CITY OF ALBUQUERQUE

RE: Alameda West Pond Certification
Engineer's Certification Date: 09/15/22
Hydrology File: B14D001B

GRADING AND DRAINAGE PLAN

SHEET	C1
-------	----

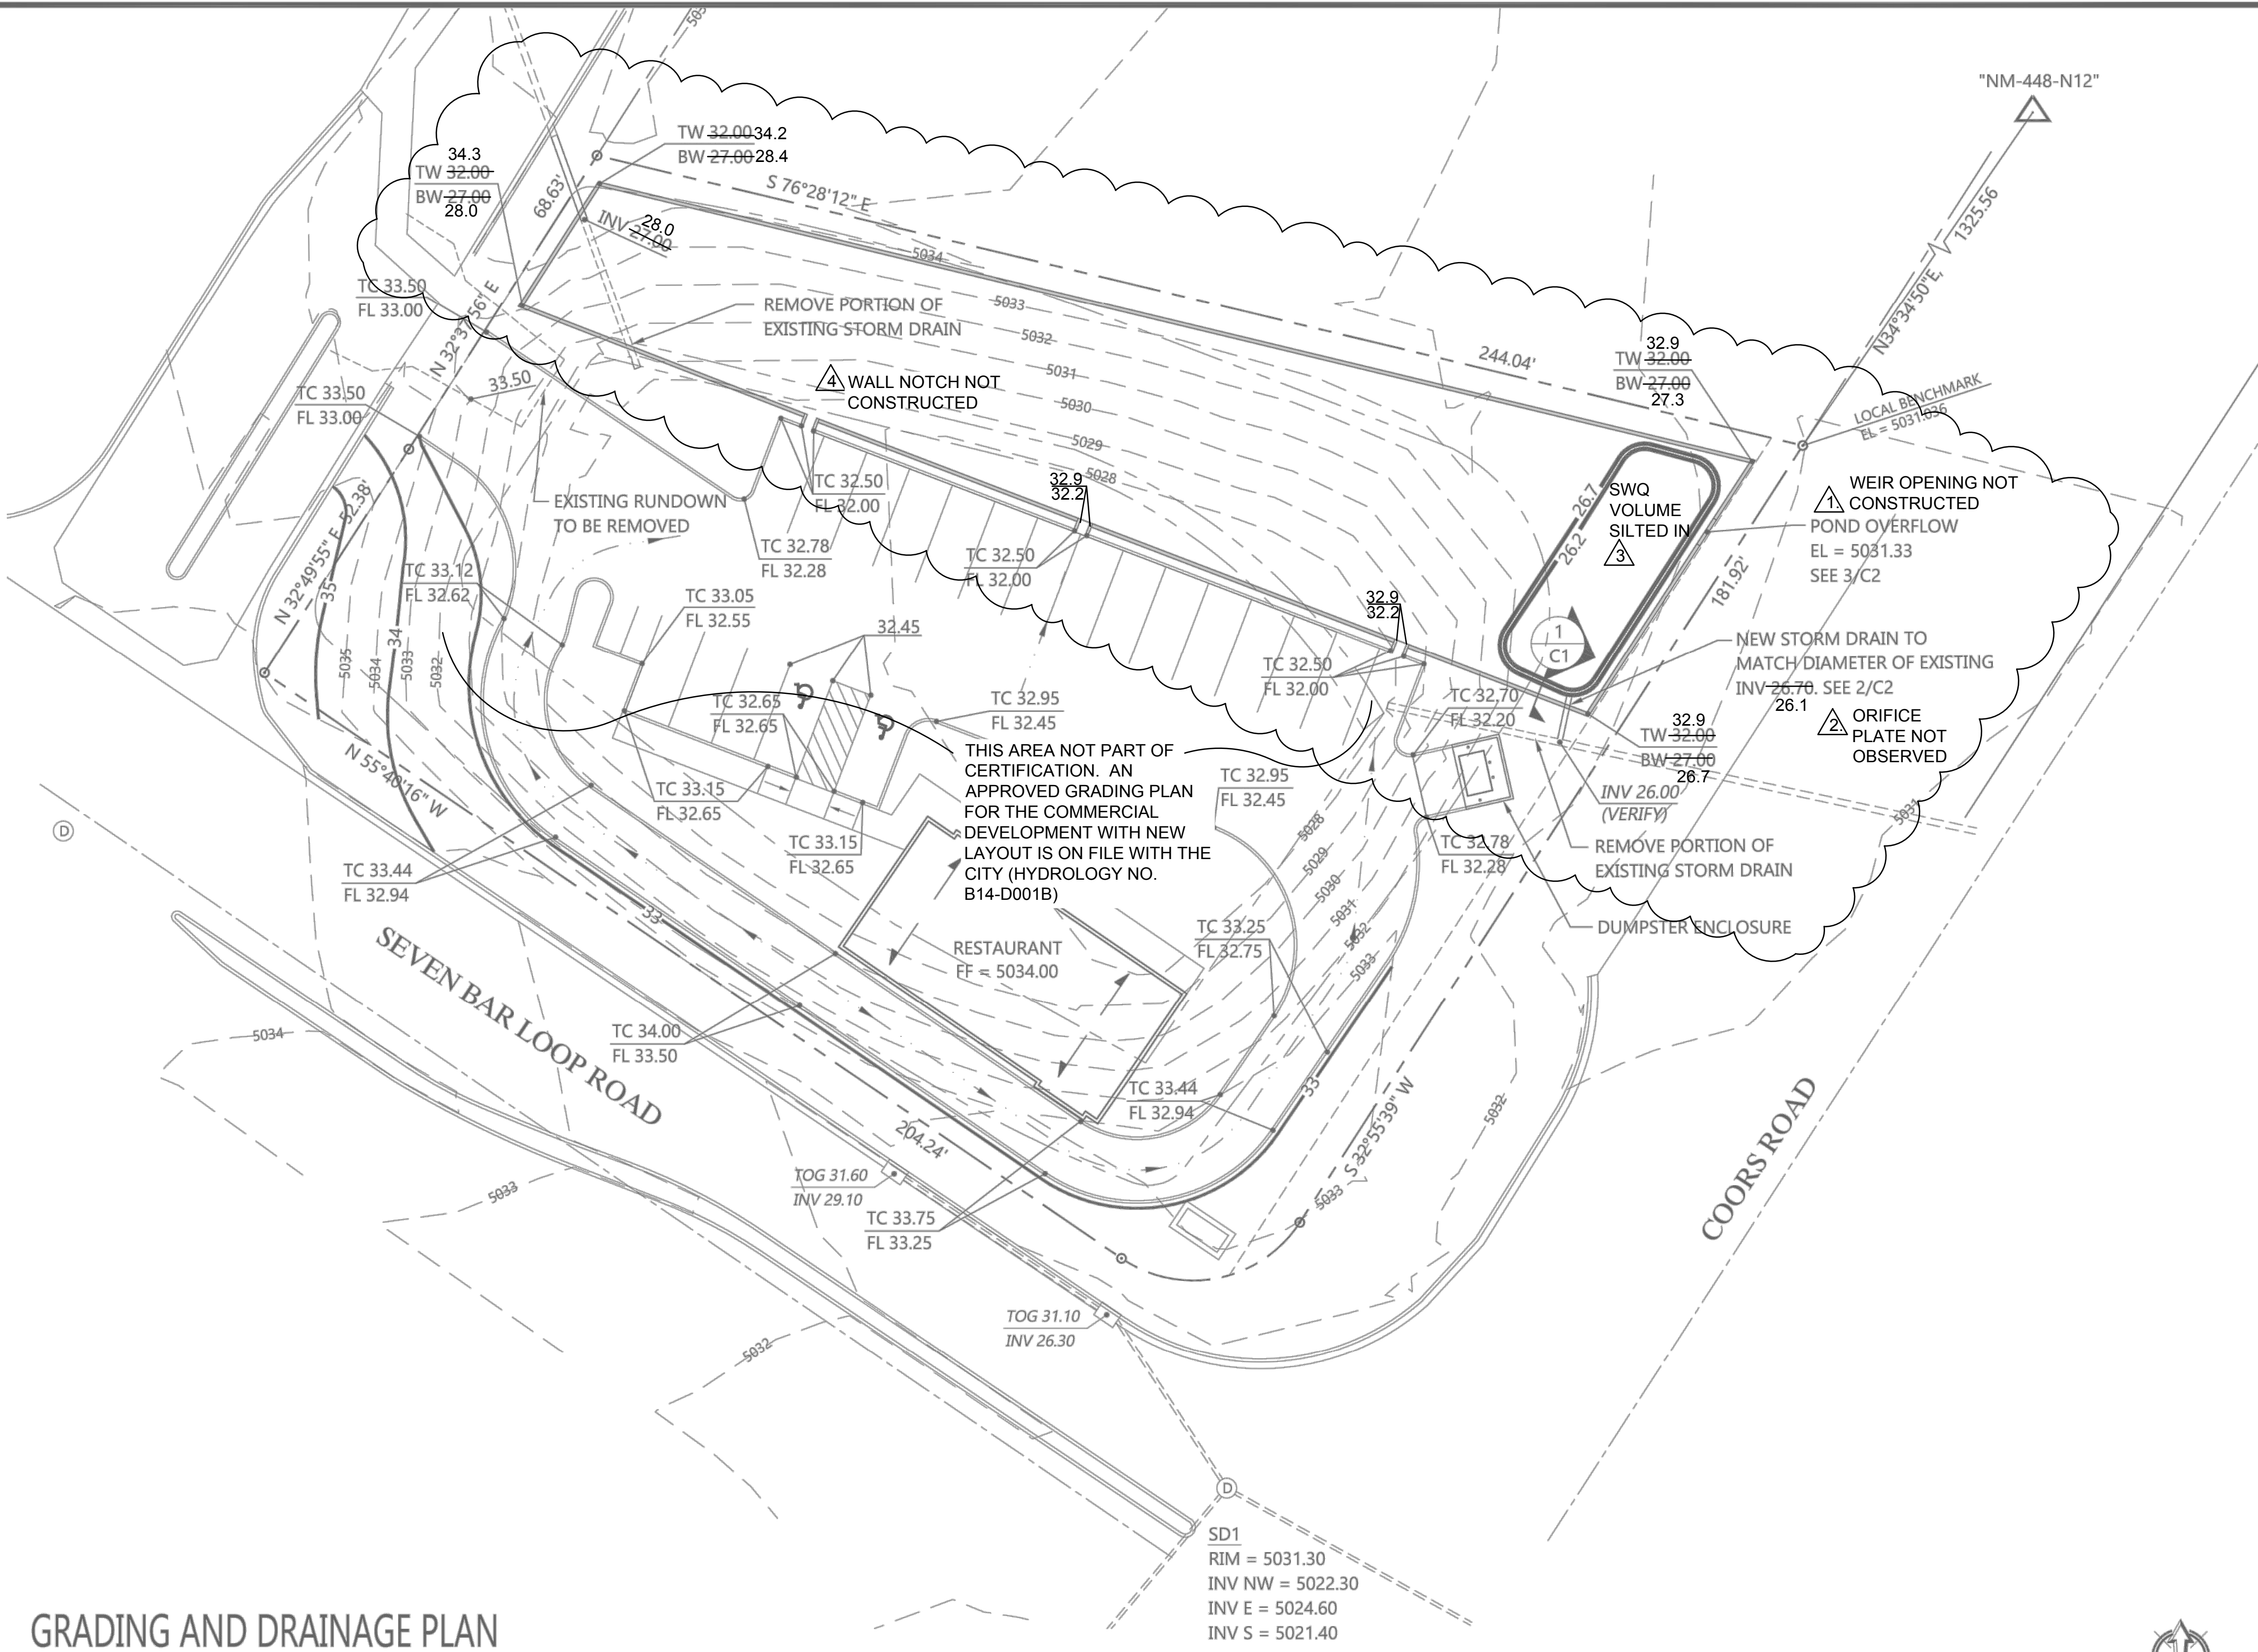
- The 4-foot weir has not been constructed.
- The orifice plate at outlet pipe was not observed to be in place.
- The storm water quality portion of the pond has silted in.
- The westerly wall notch for a rundown has not been constructed.

The outstanding improvements shall be constructed and certified with the Building Permit plans for this tract (Hydrology No. B14-D001B). The remediation plan is attached for information only.
